SIB 64 05 21

RATTLING NOISE PERCEPTIBLE IN VEHICLE INTERIOR WITH AC ACTIVATED

E-Series	Model Description	Production Date
G20	3 Series Sedan	Start of Production up to May 30 2025

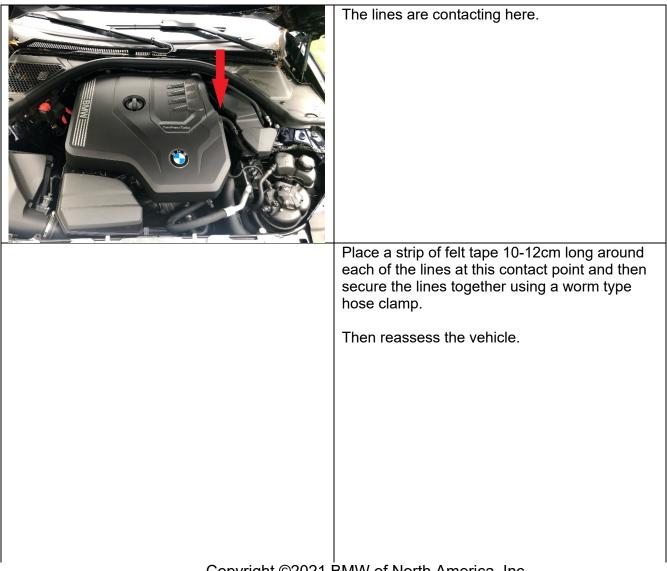
The refrigerant line double pipe and a clamp on the return line of the internal heat exchanger are in line with each other (in the direction of travel, on the left (driver) side of the engine compartment below/behind the DME).and are making contact.

Insert a strip of felt tape in the area of contact and clamp the two pipes together.
